AMENDMENT OF SOLICITATION/MODIFICATION OF CONTRACT				1. Contract Number	Page of Pages		
2. Amendment/Modification Number		3. Effective Date		4. Requisition/Purchase Request No.		5. Solicitation Caption	
GF-2013-B-0082-003		January 14, 2013				Auditorium Bldg 46E Guest Rooms and Dressing Rooms Renovation

**GF-2013-B-0082**  
**AUDITORIUM BUILDING 46E**  
**GUEST ROOMS AND DRESSING ROOMS**  
**RENOVATION**

**ATTACHMENT A (QUESTIONS & ANSWERS)**  
**TO AMENDMENT 003**

**ATTACHMENT B**  
**(ADDITIONS & MODIFICATIONS)**  
**TO AMENDMENT 003**

# Membrane Drain

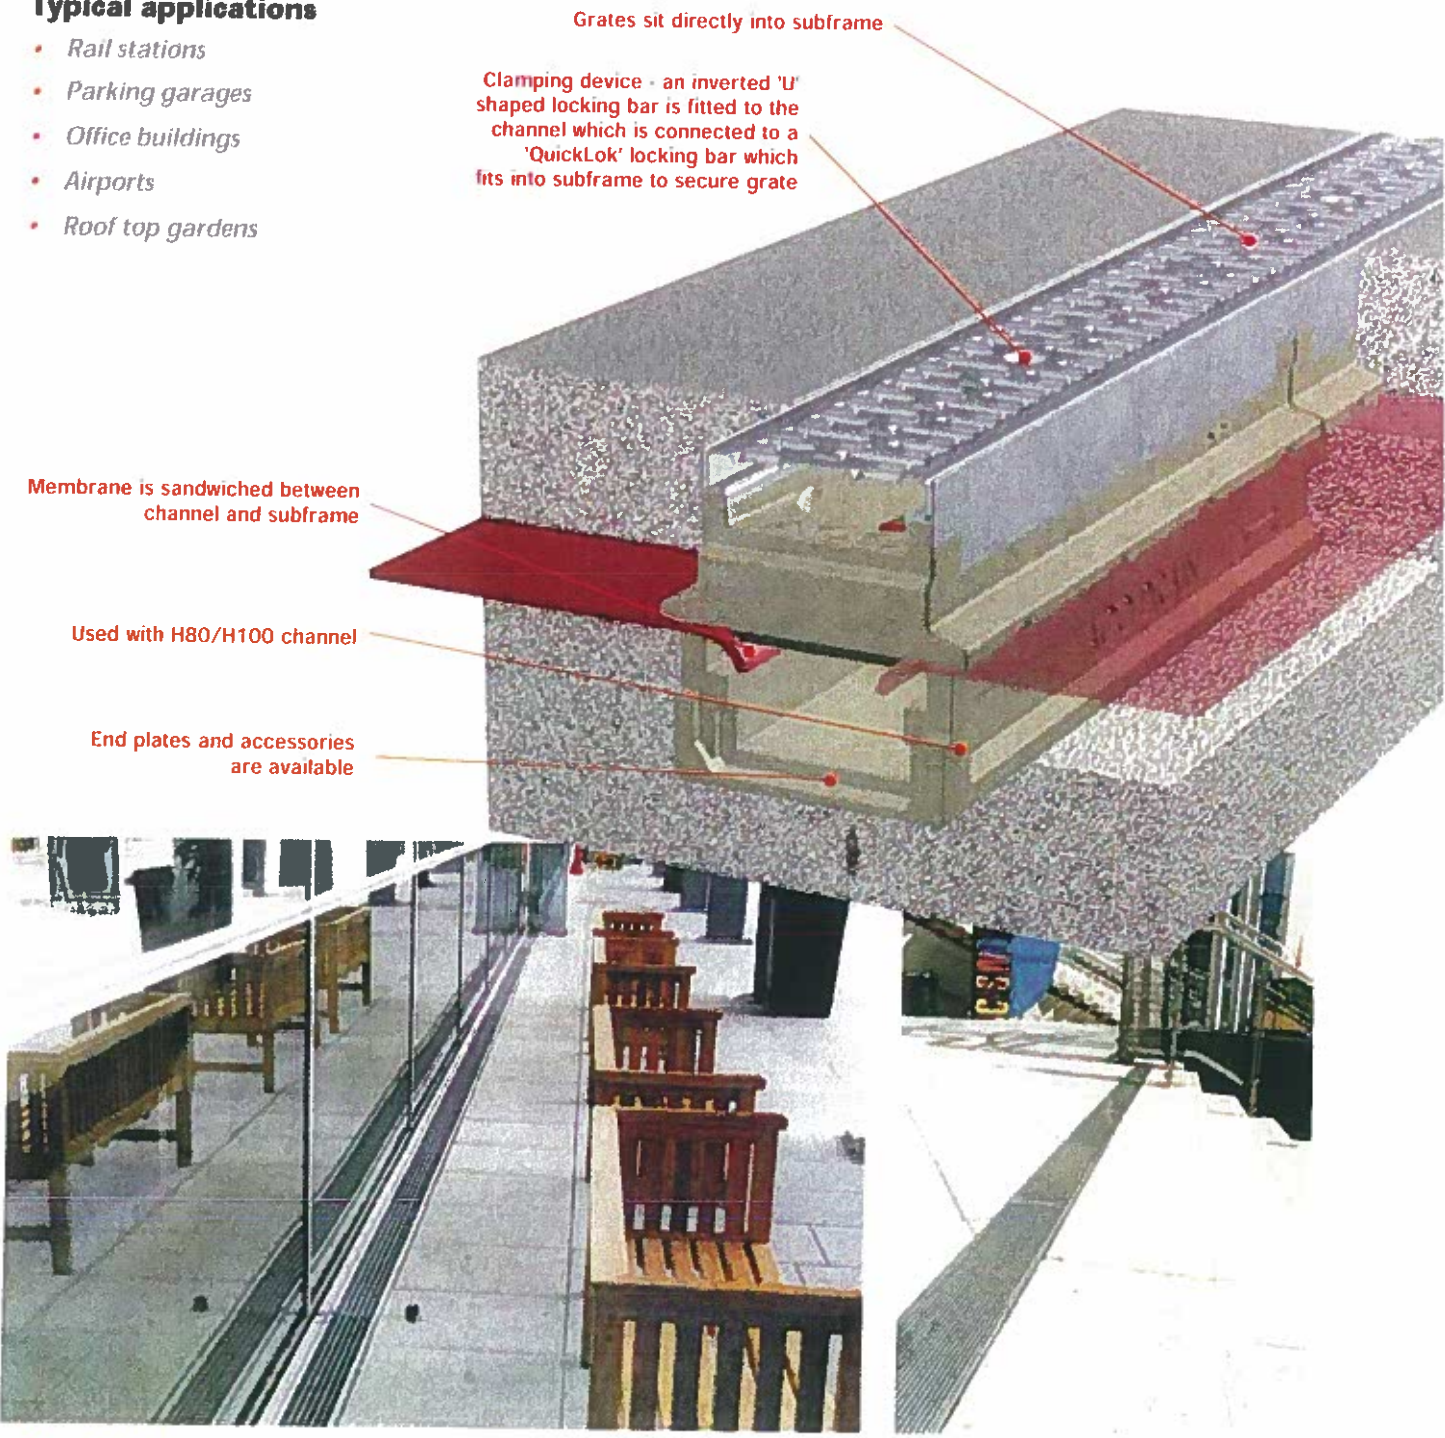
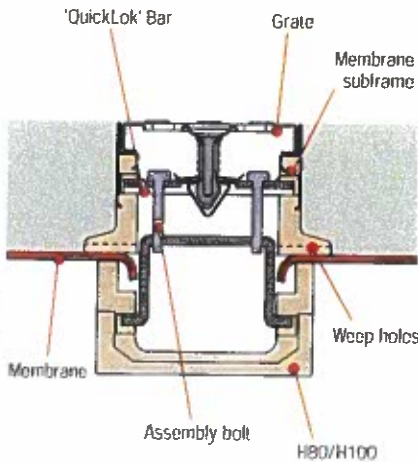
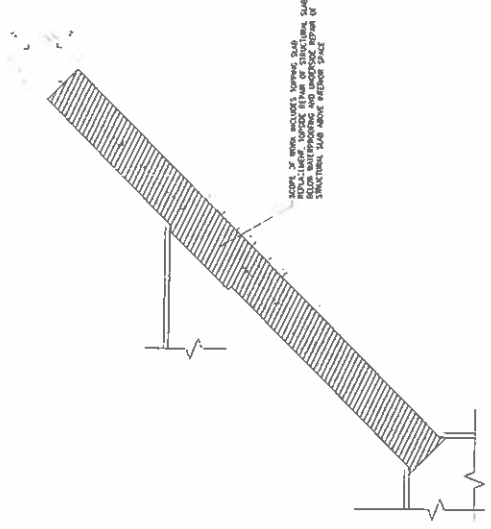
2. Question: Please provide specification for trench drain detail 9/R3.3.

**Answer: Refer to attached product information for Aco Membrane Drain.**

2 PART PLAN - LOBBY STAIR  
 3/32" = 1'-0"

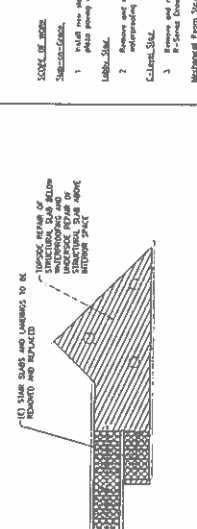
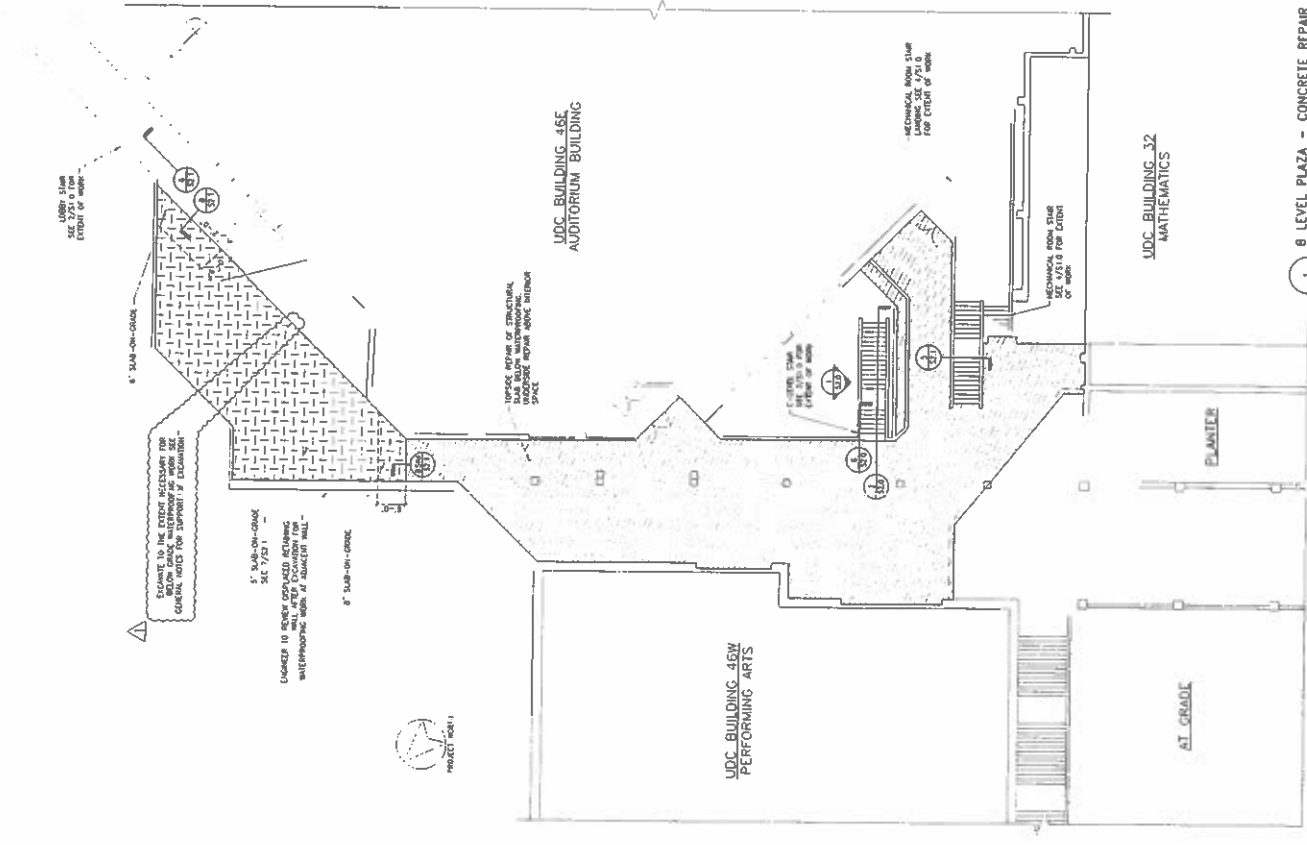
5. Detail 3, 4 and 5/A1.1. Calls for concrete steps and landings to be demolished / removed in order to excavate down to the footing of the lower exterior wall to waterproofing. Has the soil to be excavated been tested for reuse? If so where can it be stocked? Will we need to provide structural fill?

**Answer: The Contractor must refer to Plans 2, 3, and 4/S1.0 and 1, 2, 3, and 4/R1.2 for concrete stair slab work. Also, see Details 6/S2.1 and 1 and 1R/A3.3 for example of work required at Lobby Stair. Work at Lobby Stair, C-Level Stair, and Mechanical Room Stair does not include earth excavation to exterior wall waterproofing.**

**No soil designated for removal has been tested for reuse. Contractor shall refer to Note 3.3 on Drawing S0.0 for requirements at below-grade excavations, excavation support, and backfill.**

## TOILET ACCESSORY SCHEDULE

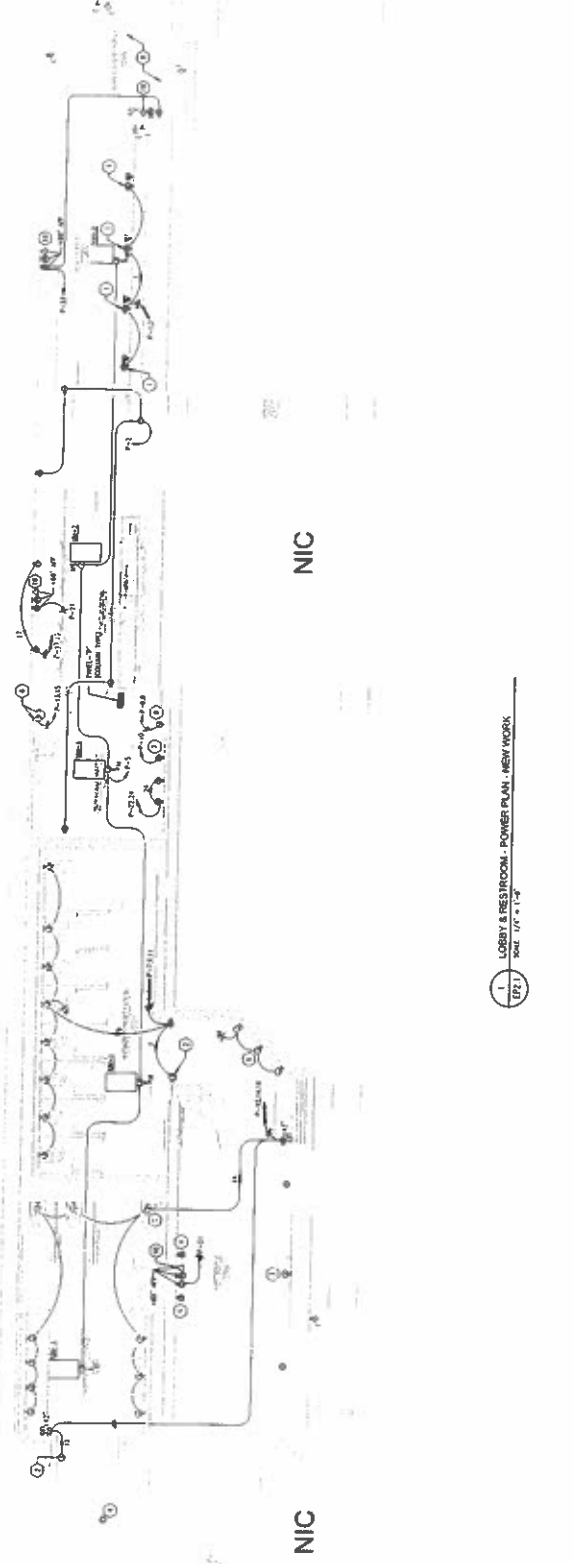
7. Question: Please provide toilet accessory schedule, the plans do not provide one.

**Answer: Refer to attached drawing AR3, dated 01/01/2013.**

2 ENLARGED ELECTRICAL ROOM  
 SCALE: 1/4" = 1'-0"

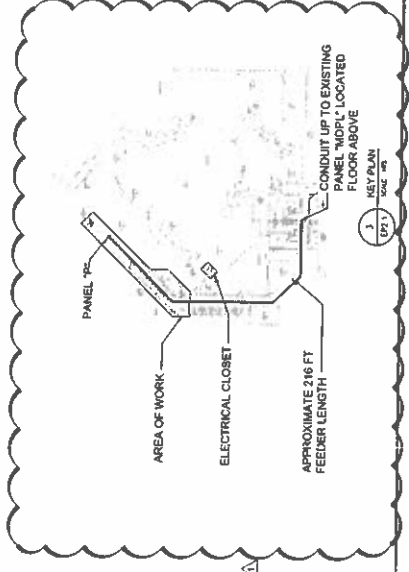
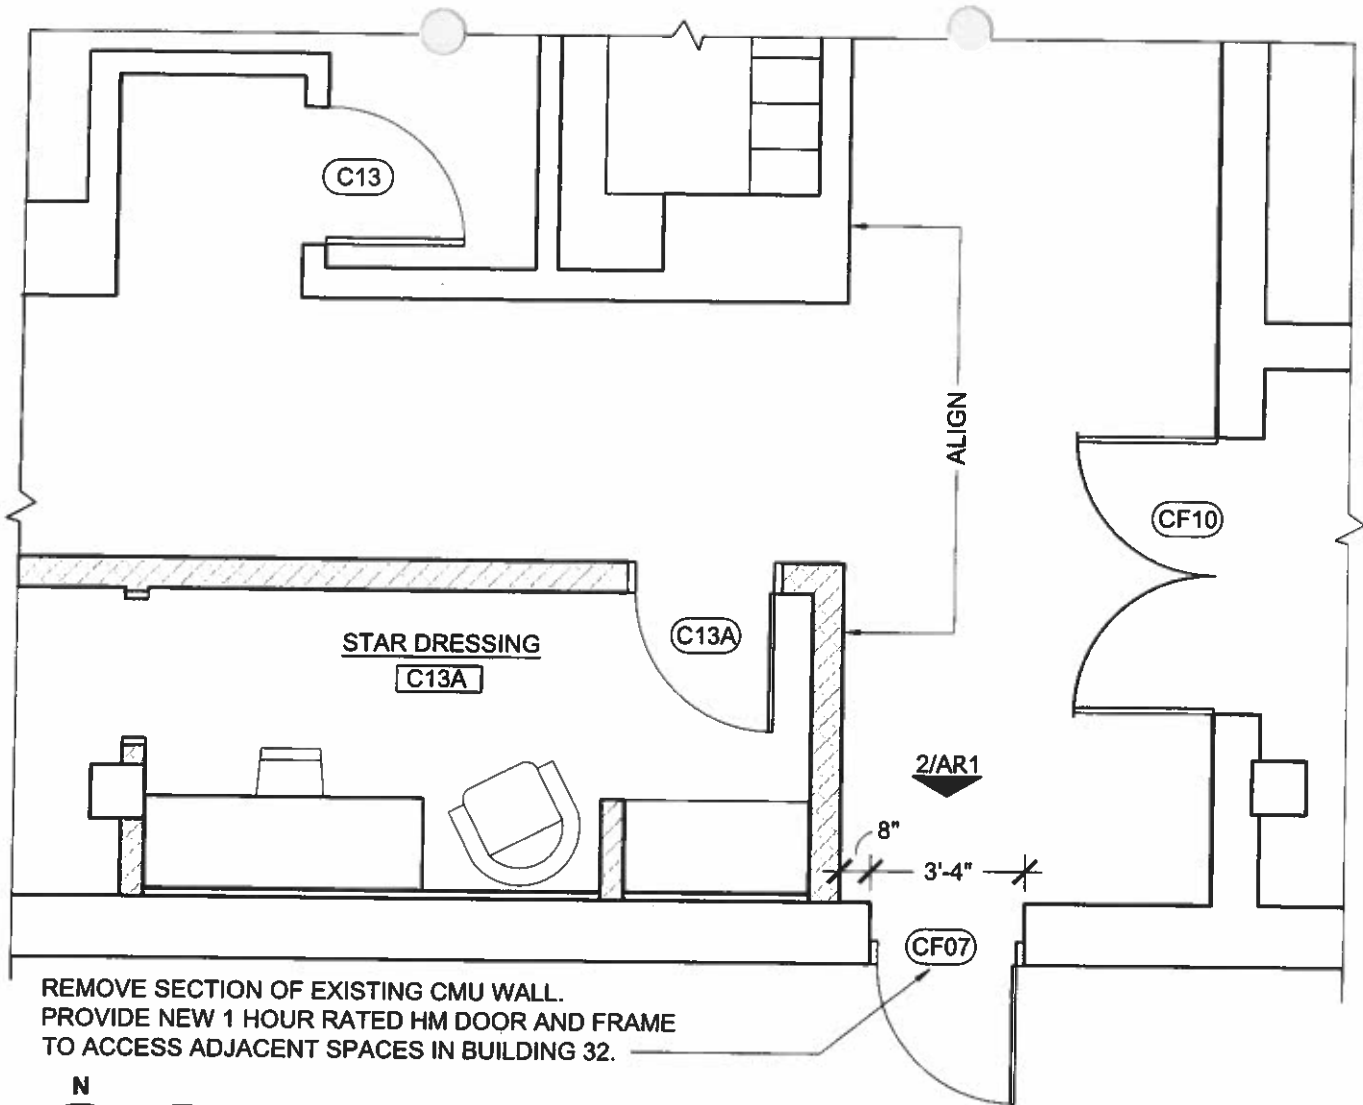
9. Question: Electrical drawings do not give the location of the existing electrical room on "B" level. What is the distance from existing Panel "MDPL" on level "B" to the new Panel "P" on level "C"?

**Answer: Refer to sheet EP2.1, Amendment 2 revisions dated 07 January, 2013, for location of electrical room.**

PROJECT:	CAMPUS AUDITORIUM BUILDING 46E, UDC VAN NESS CAMPUS	PROJECT NO:	1013
<b>KAMM</b> ARCHITECTURE 3812 VAN NESS STREET NW , WASHINGTON, DC 20016 P 202.249.2901 F 202.249.2902	SHEET:		<b>AR1</b>
	DATE:		01/07/2013

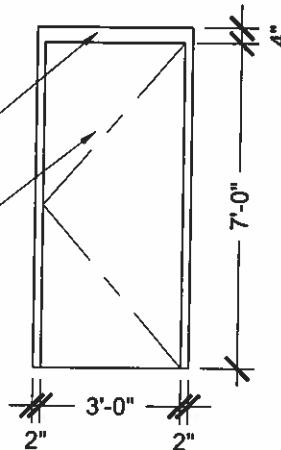
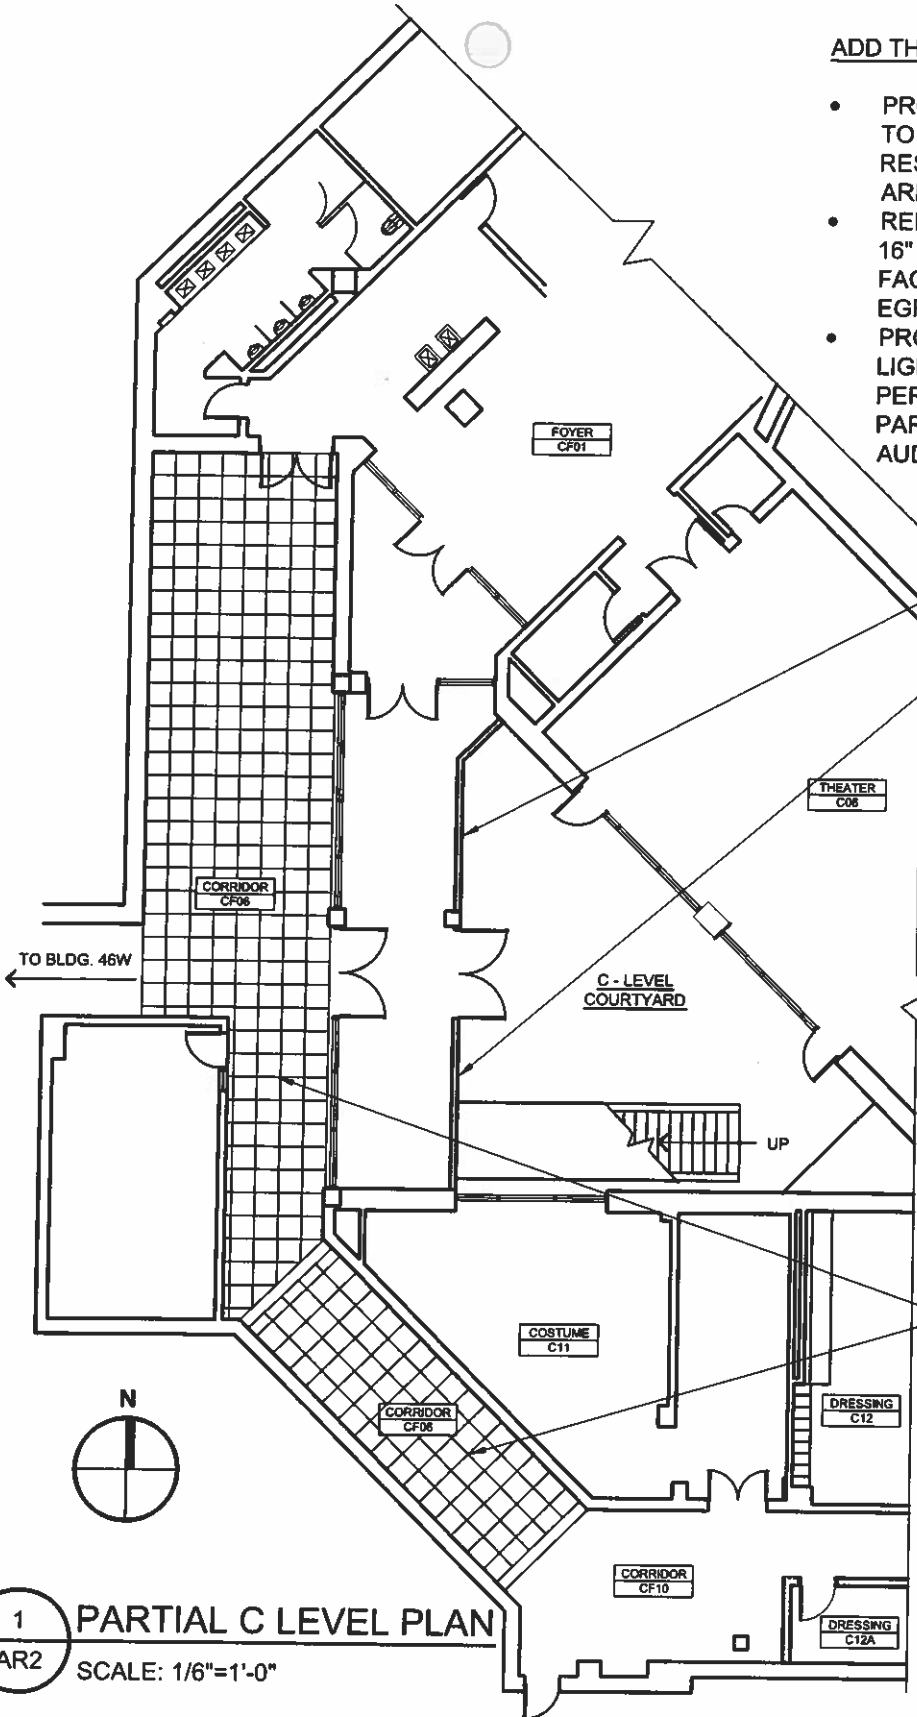
1. **ADD** scope of work depicted on attached Sketch AR1, dated 01/07/2013, to Package 2. Work includes installation of temporary door to provide access to backstage swing space in Building 32.

1 HOUR RATED HM DOOR AND FRAME. PAINT.

NOTE: AT COMPLETION OF PROJECT, REMOVE DOOR CF07, INFILL CMU PARTION, AND RESTORE WALL TO EXISTING CONDITON ON BOTH SIDES. PAINT.

- PROVIDE:
- HARDWARE SET 9 - OFFICE W/ CLOSER
  - HINGES: 1 1/2 PAIR HAGER BB1168 5" X 4"
  - LOCK: SCHLAGE L9050- 630 OFFICE
  - TRIM: SCHLAGE LEVER 02-630, ROSE A-630
  - DEADBOLT: SCHLAGE I9463-630
  - CLOSER: NORTON 8300 ARCHITECTURAL
  - STOP: IVES FS13-US32D
